CNG FUELING STATION
CONCEPT SITE PLAN

EX-1

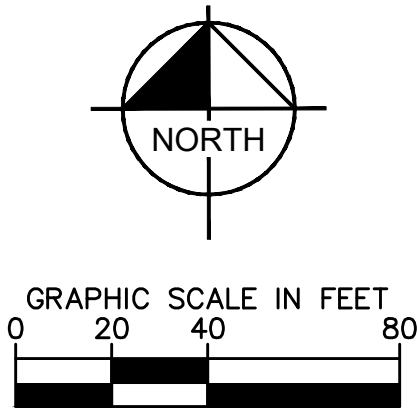
Add hydrant on north end of site. Location to be determined. (Fire)

Show existing storm sewer stubs and detail how storm water will be collected on the site. A full storm water management plan is required.

Provide a landscaping plan. No overstory trees will be allowed in drainage and utility easements.

Turning radius appears to be tight. Provide turning movements. Current design creates dead-end design not conducive to vehicle movements. (Fire)

Show Shakopee fire truck and other worst case design vehicle.

What is the purpose for this large open paved area?

Eliminate this dead end parking row. Somehow needs to be connected via a drive-aisle so it has an outlet.

Additional information is needed on the gate (time to open, how is access controlled, etc.). Current layout only has room for one vehicle to queue. Provide additional queuing space so queuing vehicles do not block the sidewalk or public street.

Gates require installation of fire department keybox. Keybox to be tied to controller if gate is powered. (Fire)

Provide the city a copy of the agreement from the gas company allowing improvements (fence, pavement, etc.) in the easement area.

Is there a structure proposed for the timefill system?
